JBR Environmental Consultants, Inc. Re: COVOL 97G

## Application for Permit Processing Detailed Schedule of Changes to the MRP 9/30/97

Title of Application: **Wellington**

**Modular Coal Fines Wash Plant Constr. # 2 (Add'l Info.)**

Figure  
Northwest Tailings Dike - Safety Factors

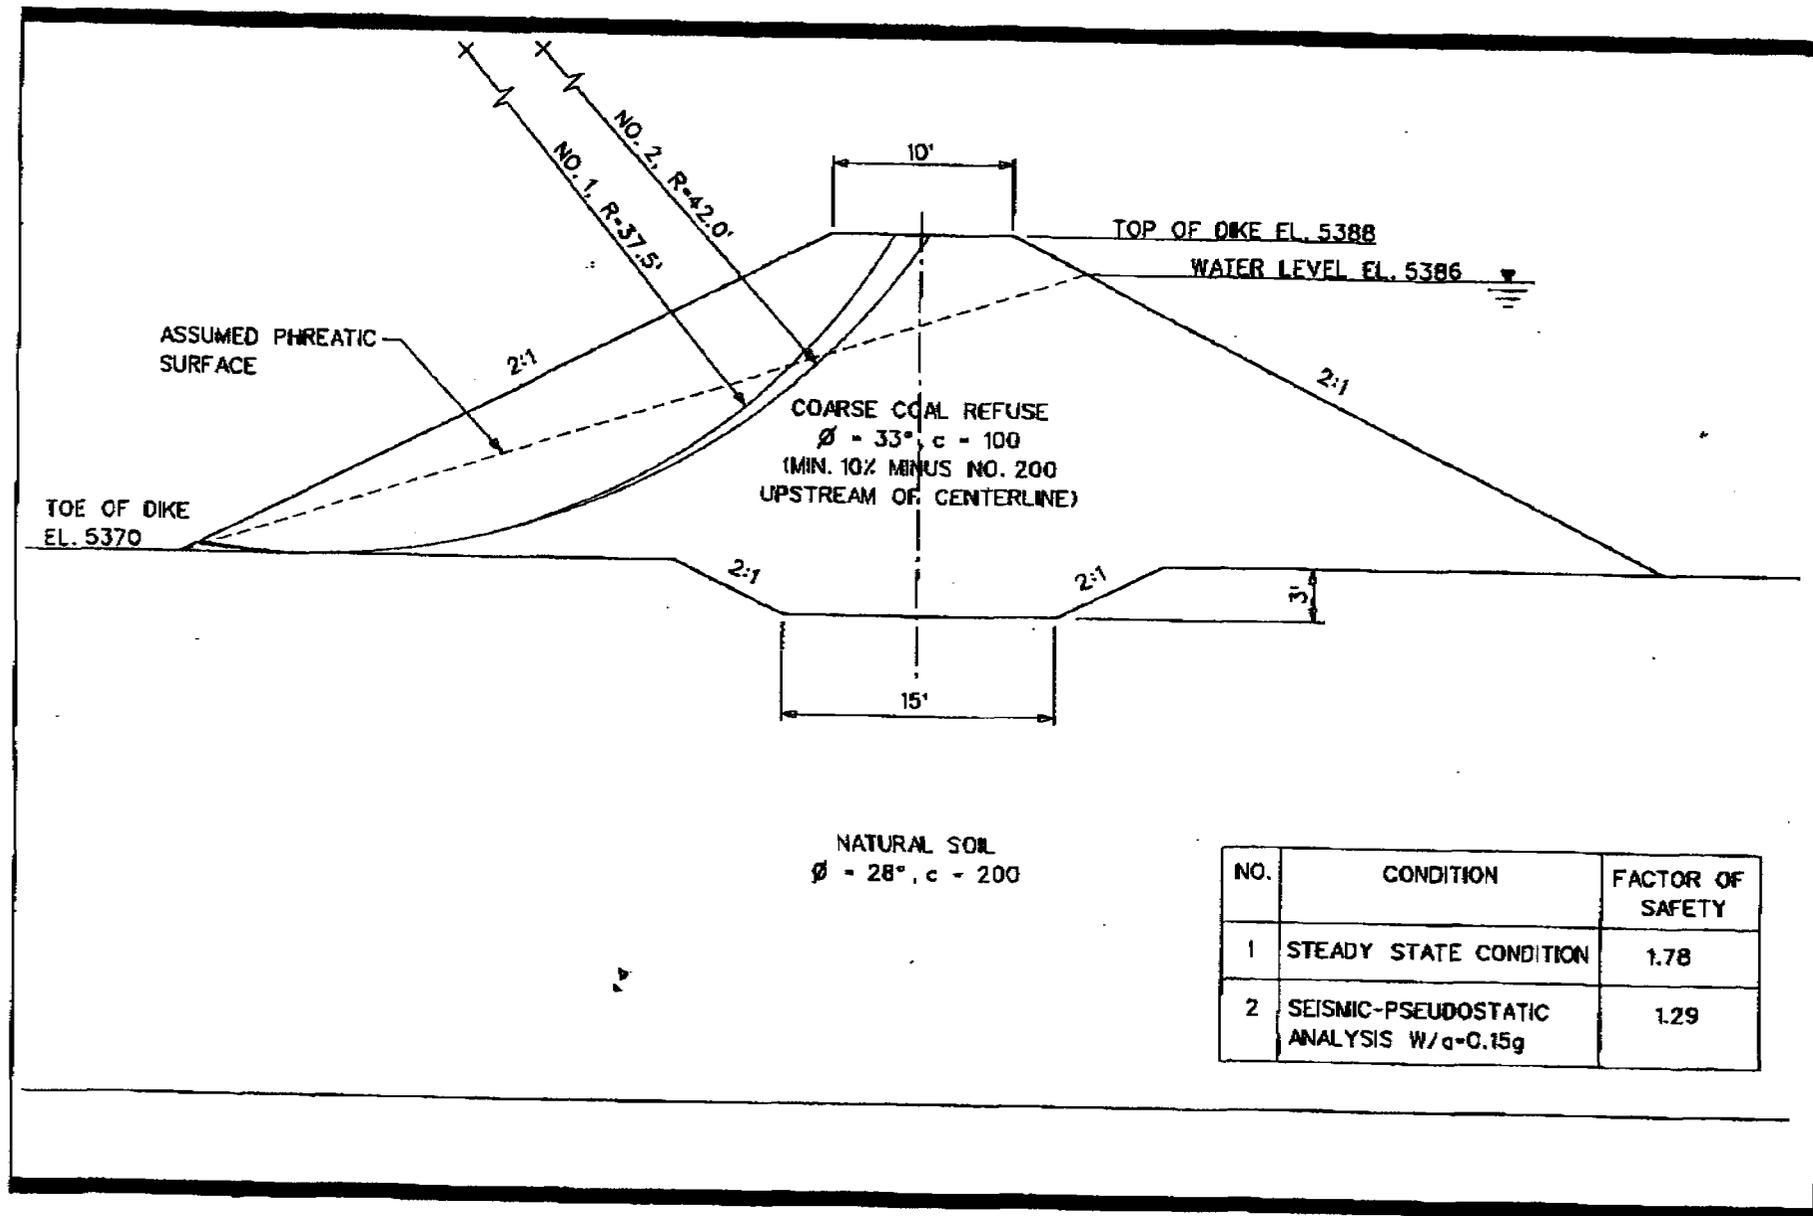
At your request, stability analyses have been performed for the proposed Northwest Tailings Pond Dike at the COVOL Technologies Project near Wellington, Utah. The analyses included Steady State Seepage and Seismic Pseudo Static. It does not appear that a Sudden Drawdown Condition will exist and hence Sudden Drawdown analysis was not performed. The strength parameters for the embankment coarse coal refuse and the natural soil were obtained from the 1983 Study and the Subterranean Associates borehole which was referenced in the September 5, 1997 letter.

The analyses were performed on the proposed cross section transmitted with the Sept. 5 letter. The results of the analyses are presented in the enclosed figure. The analyses were performed using a computer adaption of Spencer's Method which satisfies both force and moment equilibrium. It will be observed that a Factor of Safety of 1.78 was obtained for the Steady State Condition and a Factor of Safety of 1.29 was obtained for the Pseudostatic Analysis. We believe that these factors of safety are adequate for the proposed dike and recommend that the cross section and construction recommendations made in the Sept. 5 correspondence be utilized.
